Docket ID NRC-2013-0070

**A REVIEW OF THE NRC¹ PROPOSED DETERMINATION OF NO SIGNIFICANT
HAZARD CONSIDERATION FOR SOUTHERN CALIFORNIA EDISON'S PROPOSED
LICENSE AMENDMENT FOR SAN ONOFRE UNIT 2**

DECLARATION OF JOHN LARGE

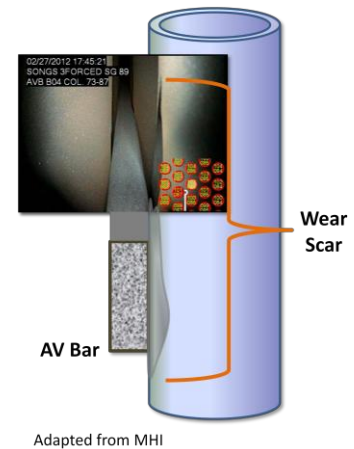
6.3.1 **In-Plane:** To generate this pattern of wear at the AVB the tube (shown right) moves relative to the AVB in the *in-plane* direction (up-and down). The resulting wear scar sits across the AV bar depth indicating relatively large *in-plane* motion amplitude.

6.3.2 This wear arises because the 'zero tube-to-bar gap and zero-preload' design functionality of the AVB provides no tube restraint the *in-plane* direction leaving the tube free to respond and slide (up and down) across the AV bar contact surface.

6.3.3 This pattern of wear scar is much longer than the typical case adopted in the *Updated Final Safety Analysis Report* (UFSAR)¹⁴ for which the scar length is assumed to equal the AVB-to-tube contact length (ie the AV bar cross-section depth). In this case the UFSAR is overly optimistic in determining the permissible tube wall wear depth because it is generally accepted that tubes with shorter wear scar lengths exhibit higher burst pressures.

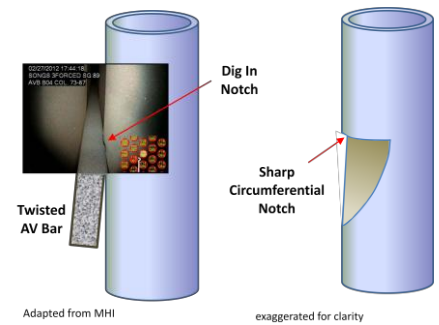
6.3.7 For failure analysis, account of this *stress raiser* is taken by assuming a *stress concentration factor* (k_t) determined by the dimensional geometry of the notch. Since the detection of this wear is blind from within the tube it is impracticable to determine the sharpness and depth of the notch so, it follows, the appropriate value of k_t cannot be chosen with absolute certainty.¹⁵

6.5 These two latter wear patterns (§6.3.6 and §6.3.9 - as shown by photographs reproduced from the MHI inspection)¹³ highlight the difficulty of accessing the wear scars to determine the extent of surface damage. Much the same applies to the locations of the TTW, where the close proximity of adjacent tubes practicably limits access for visual inspection.

FIGURE 1 INTERTEK PROJECTION OF CYCLE 17 TUBE DEGRADATION

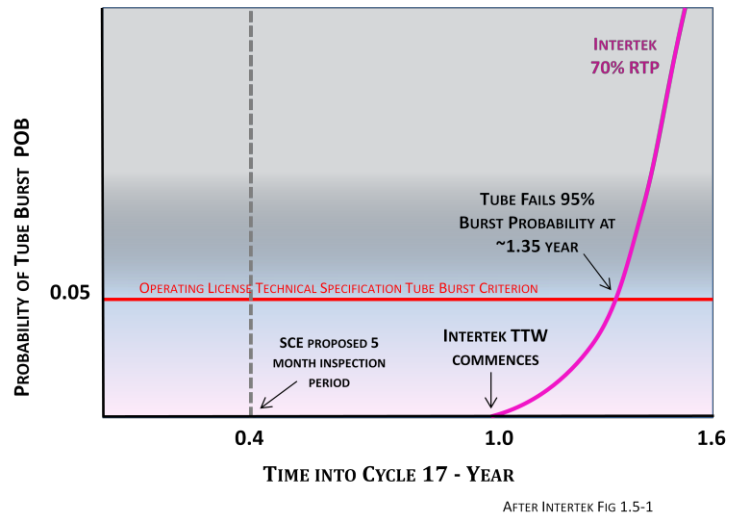
7.17 Intertek's projection for rate of TTW for the proposed Unit 2 restart (Cycle 17) is summarized by the following graphic:²³

7.18 The 1st stage AVB-to-tube restraint loosening proceeds from the time of restart over a period of 12 months at which time a group of successive AVBs have little or no preload force in the *in-plane* direction.

7.19 From this point forward the 2nd stage wear process (TTW) commences following the characteristic (—).

7.25 **In summary:** There are two important issues raised by the AREVA and Intertek OAs, these are, first, both of these independent analyses conclude that even at the reduced 70% RTP level of operation, the AVB-to-tube wear³⁰ and TTW will continue to be present in the RSG tube bundles of Unit 2; and second, each OA arrives at significantly different time projections for individual tubes in the tube bundles of the RSGs to reach and exceed the TS tube burst failure criterion.

FIGURE 2 AREVA PROJECTION OF CYCLE 17 TUBE DEGRADATION

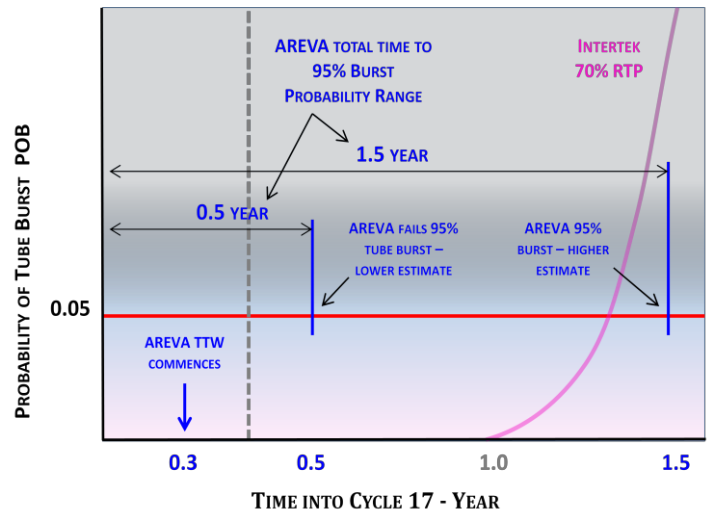
7.22 However, Intertek's projections do not compare at all favorably with the timings evaluated by the AREVA OA²⁹ because:

7.23 for AREVA (shown thus), the AVB-to-tube restraint loosening period until the 2nd stage TTW commences is about is ~0.3 year compared to 1 year by Intertek; and similarly

7.24 the equivalent total time to tube burst (95% probability) projected by AREVA is in the range of 0.5 to 1.5 year compared to ~1.35 year Intertek.
